JOINT AAC/ PLANNING COMMISSION STAFF REPORT

DATE: February 22, 2017

SUBJECT: CITY OF PALM SPRINGS REQUEST FOR APPROVAL OF A MAJOR ARCHITECTURAL APPLICATION FOR A 2,820 SQUARE-FOOT ADDITION AND RENOVATIONS TO FIRE STATION #4, LOCATED AT 1300 LA VERNE WAY, ZONE CU (CASE 3.4012 MAJ).

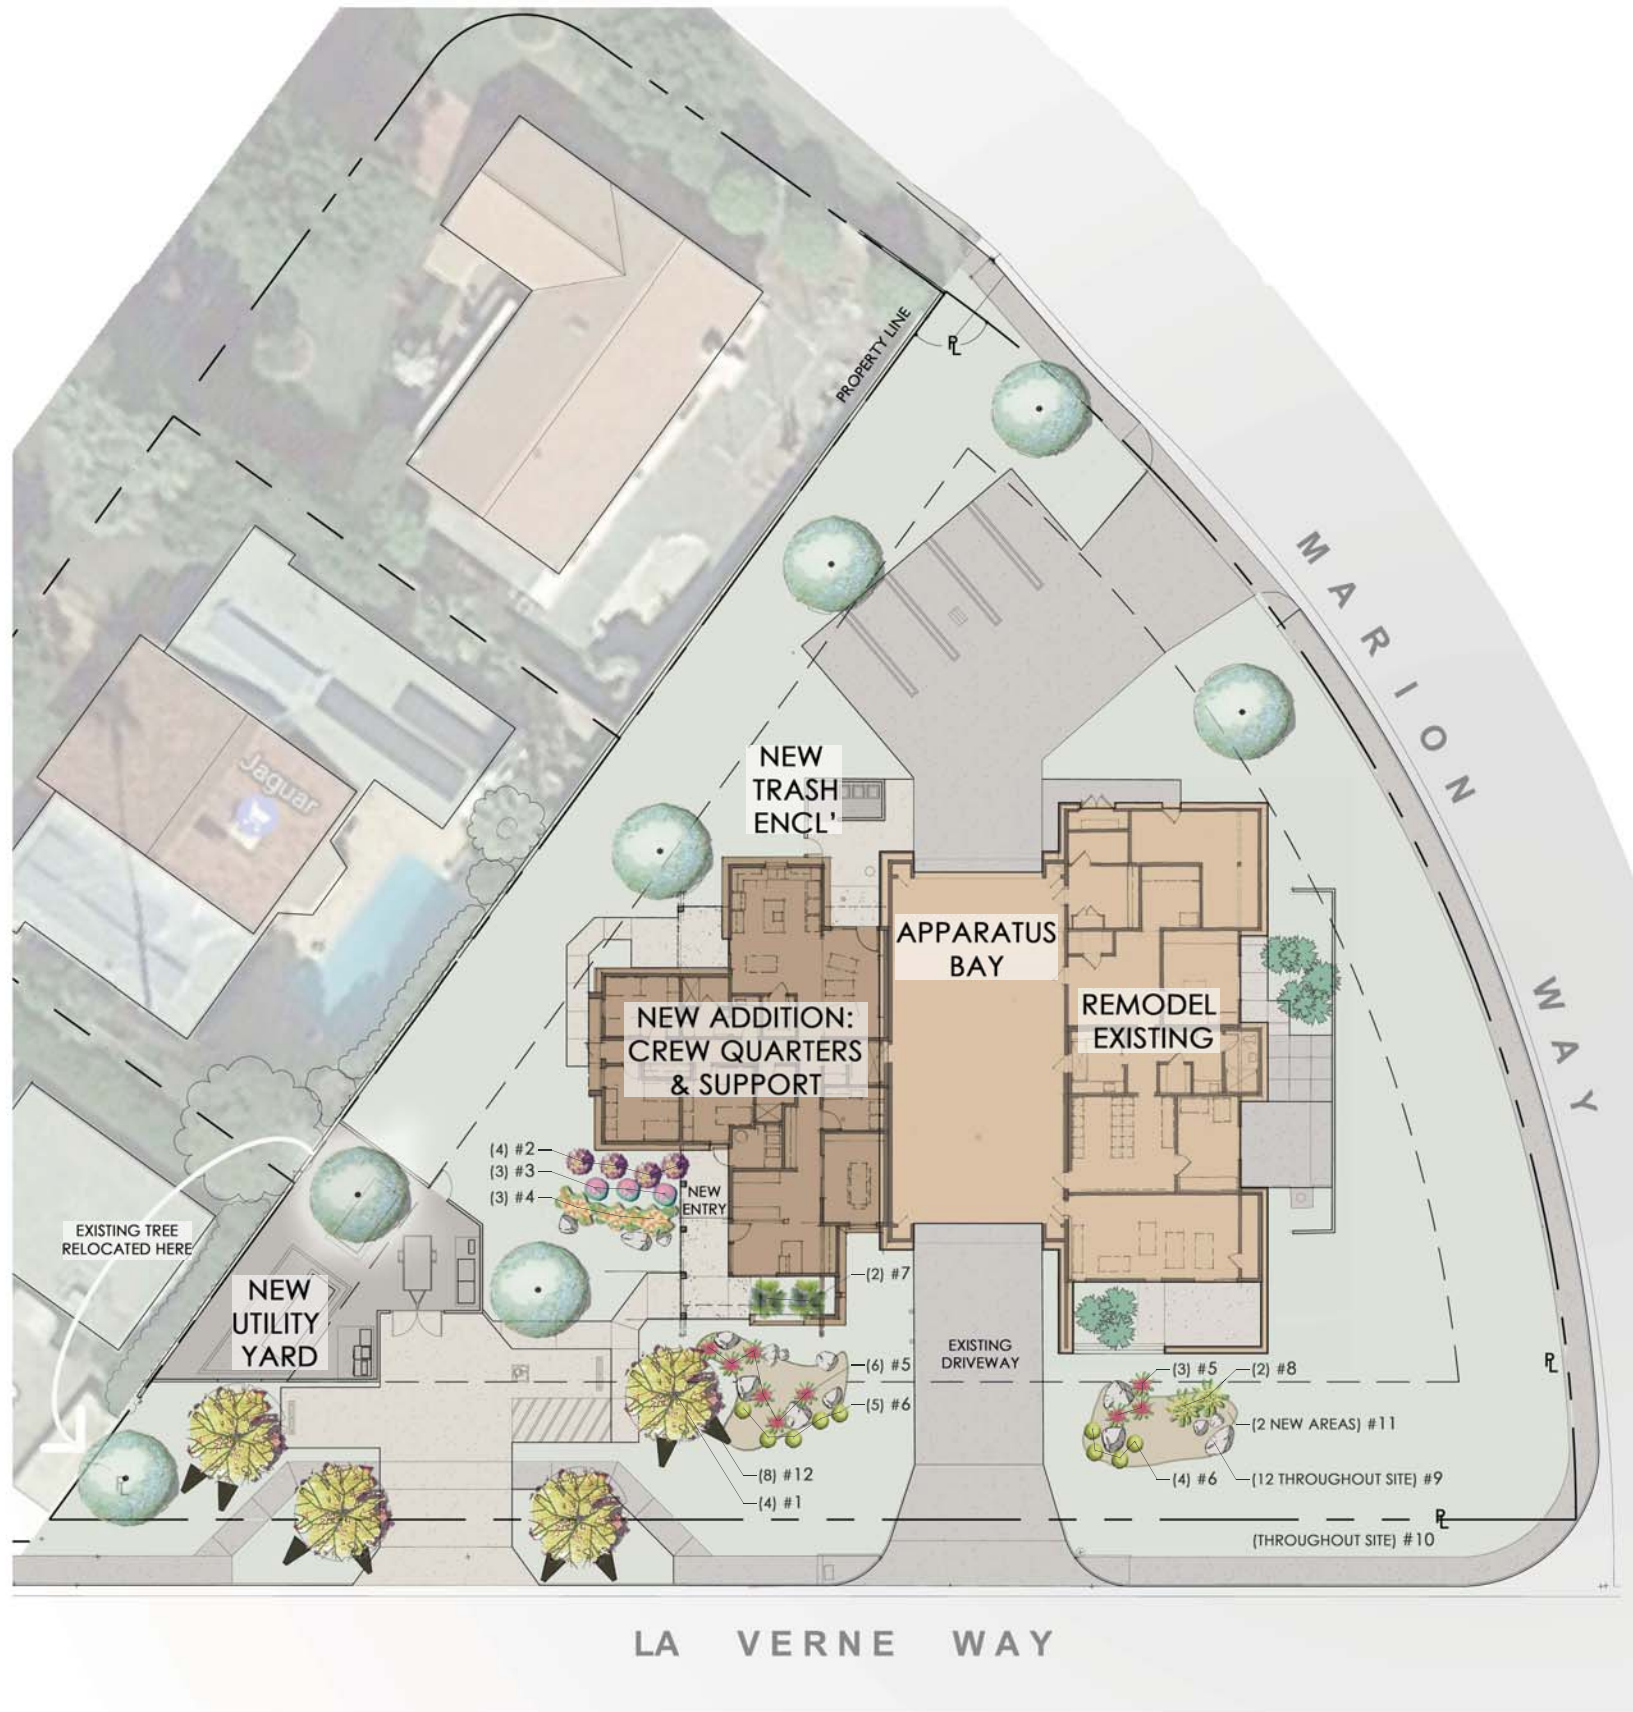
Changes to the landscaping will be minor, with most of the new landscaping placed along the La Verne frontage or adjacent to the proposed addition. The landscape plan depicts the addition of four Desert Museum palo verde trees at the front of the property adjacent to the new parking area, which will assist in complying with the parking lot shading requirements. The existing olive trees along the west property line and along the Marion Way frontage will be retained, as will the Mexican fan palms located adjacent to the existing structure. Two planting areas will be added and enhanced at the front of the site, utilizing a mixture of Golden Barrel cactus, Red Yucca, and Pendula Yucca plants. Weathered granite boulders (between 18" and 30" in size) will also be utilized in these two planting areas, along with Apache Sunset crushed stone as a groundcover. New plantings will also be placed adjacent to the entry of the proposed addition, consisting of Chihuahuah sage, Thunder Cloud sage, Sunburst lantana, and Mediterranean fan palms. The existing decomposed granite (Palm Springs Gold) will be retained in the remaining areas of the site. PSZC Section 93.06.00(C)(12) requires that a landscaped berm or a low wall be installed where parking areas are located along street frontages. The landscape plan will need to be modified to include the parking lot screening.
